Reliability Analysis Update

Transmission Expansion Advisory Committee
June 8, 2021

Dominion Transmission Zone: Baseline Second Chickahominy 500/230kV Transformer

Solution Update

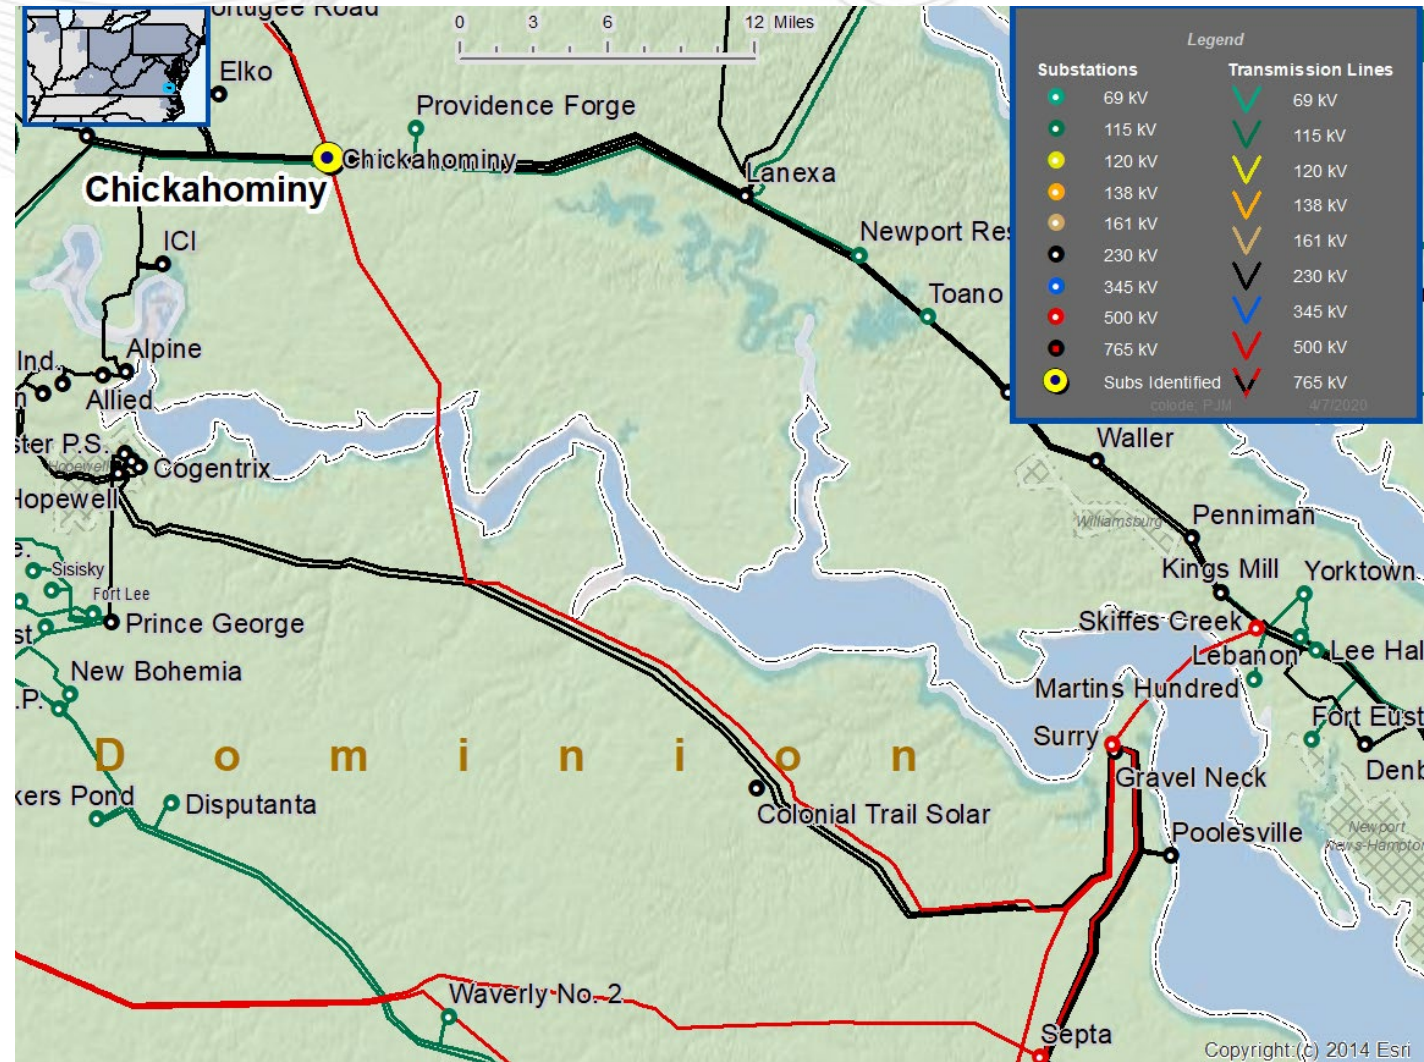
Problem Statement: Generation Deliverability - Chesterfield 5 and 6

- Chickahominy 500/230 kV transformer is overloaded for loss of Chickahominy – Surry 500 kV line

- Install a 2nd Chickahominy 500/230 kV transformer
- Relocate the Chickahominy – Elmont 500kV line #557 to terminate in a new bay at Chickahominy substation and relocate the Chesterfield – Lanexa 115kV line #92 to allow for the expansion of the Chickahominy substation
- Add three new 500 kV breakers with 50kA interrupting rating and associated equipment

Estimated Project Cost: ~~\$22M~~ \$31.05M

Recommend Solution: (b3213)
